Fresenius Medical Care SERVICE BULLETIN

Equipment: 2008K Hemodialysis Machines
Bulletin: 05-FRK-005 Rev. A
Subject: Blood Pressure Module Incompatibility

Figure 1 – Functional Board Part Number Locations

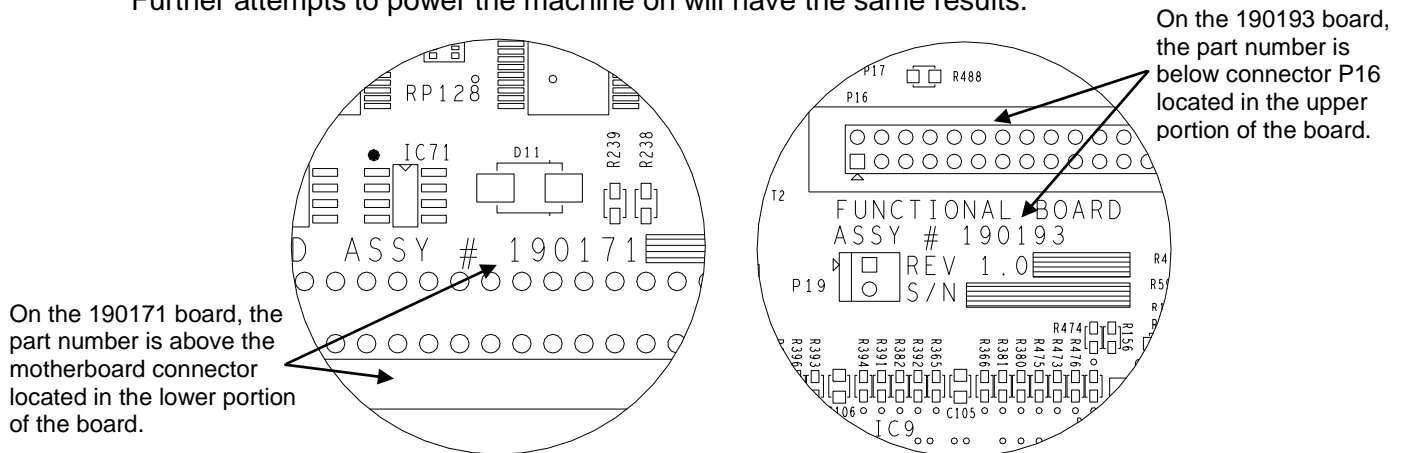
When replacing a non-functioning Blood Pressure module with either a model M2600 or a model TM-2910 Blood Pressure, make sure that the Functional board has a part number of 190193. If your machine has a part number 190171 Functional board, the 2008K will not fully initialize during the powering up sequence, forcing the machine to be turned off. Further attempts to power the machine on will have the same results.

If you have a part number 190171 Functional board and are installing one of these models of Blood Pressure modules, Fresenius will exchange your part number 190171 Functional board with a 190193 Functional board at the exchange price rate.
